TJ824-01F02 Independent Noise Advice (r10)

NSW Dept of Planning & Environment

## **Hume Coal Project & Berrima Rail Project - Noise & Vibration Assessments | Independent Noise Advice**

**Figure 1 Staging of construction scenarios**

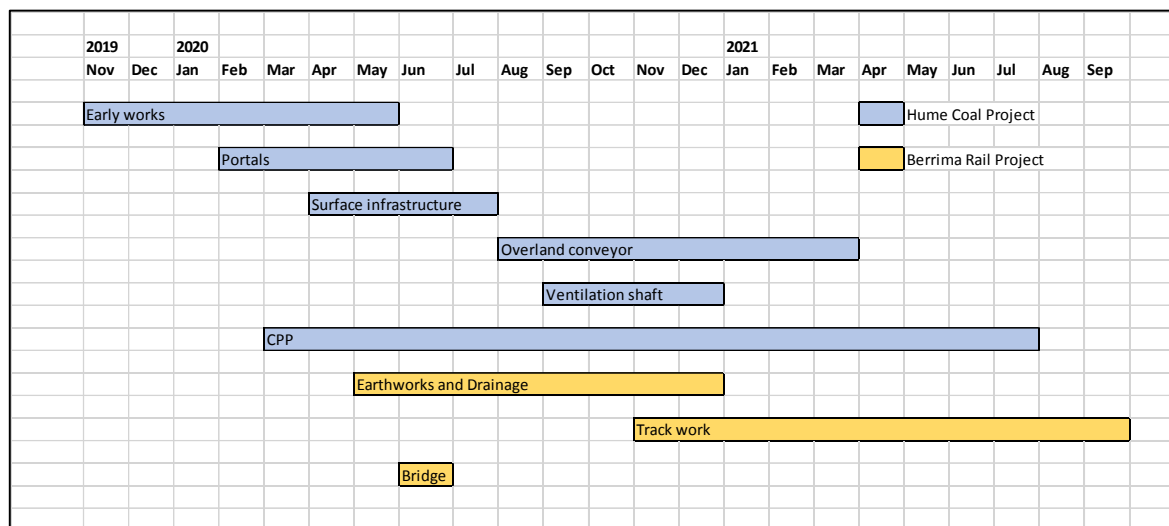
The third criticism is that the calculations in Appendix D of the Hume Coal NVA relate to one scenario occurring at the one time. There is no consideration of cumulative noise impacts when multiple scenarios occur as evidenced in the following query.

Figure 1 below shows the interleaving nature of the construction works extracted from the timing information provided in Appendix C of the Hume Coal NVA. In Appendix D of the Hume Coal NVA, noise impacts at each dwelling from each of the construction scenarios are determined independently (such as from Early Works, Portals, Surface Infrastructure etc). However, at any point in time, the cumulative noise impacts from a multiplicity of scenarios is not considered. For example, in June 2020, construction involves the Portals, Surface infrastructure, CPP, Berrima Rail Earthworks and Drainage and the Rail Bridge construction). This is true also of the cumulative construction activity from the Hume Coal Project and the Berrima Rail Project which is shown as overlapping in Figure 1 below. Whilst the assessment is complicated in that noise from two scenarios may not impact on the same residential receiver, the point is that a cumulative assessment has not been made to determine whether there are likely to be additional construction noise impacts.

Fourthly, there is no appreciation from the point of view of each receptor dwelling as to what noise levels they will be exposed to during the course of the construction.

The time-line requested is provided in Figures 7-12 of the Hume Response Report for receptor locations 10, 17 and 54. These figures provide a realistic appraisal of construction noise impacts at these receptor locations.

Recommendation 5: We recommend the preparation of a comprehensive construction noise and vibration management plan (CNVMP) to be submitted to the Department for review and approval. The CNVMP should incorporate the following key elements:

Recommendation 6: It is recommended that the CNVMP address construction noise impacts in terms of the time-line form depicted in Figures 7-12 of the Hume Response Report.

**Figure 2 Staging of construction scenarios**

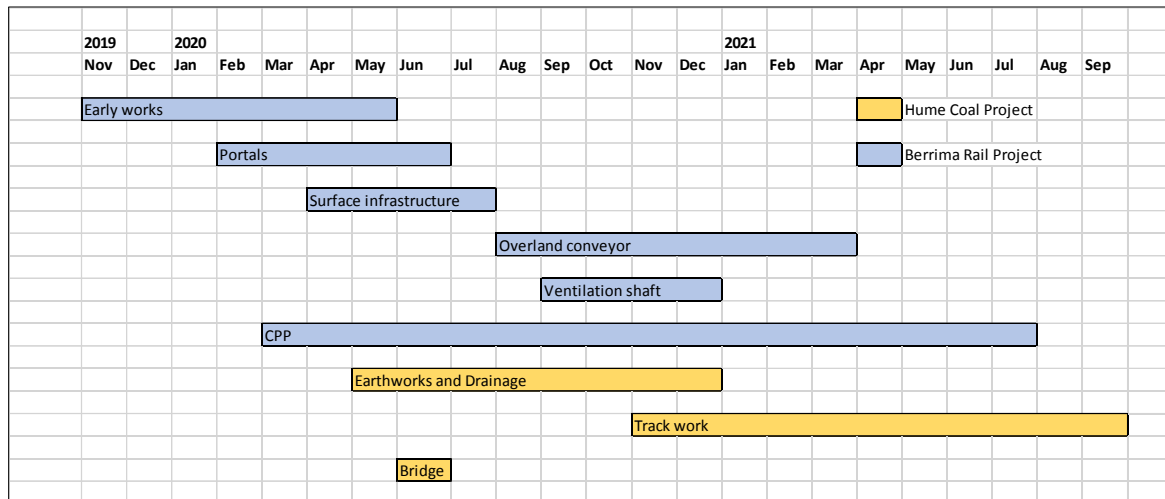
**Query 14:** Figure 1 below shows the interleaving nature of the construction works extracted from the timing information provided in Appendix C. In Appendix D, noise impacts at each dwelling from each of the construction scenarios are determined independently (such as from Early Works, Portals, Surface Infrastructure etc). However, at any point in time, the cumulative noise impacts from a multiplicity of

scenarios is not considered. For example, in June 2020, construction involves the Portals, Surface infrastructure, CPP, Berrima Rail Earthworks and Drainage and the Rail Bridge construction). This is true also of the cumulative construction activity from the Hume Coal Project and the Berrima Rail Project which is shown as overlapping in Figure 1 below. Whilst the assessment is complicated in that noise from two scenarios may not impact on the same residential receiver, the point is that a cumulative assessment has not been made to determine whether there are likely to be additional construction noise impacts.
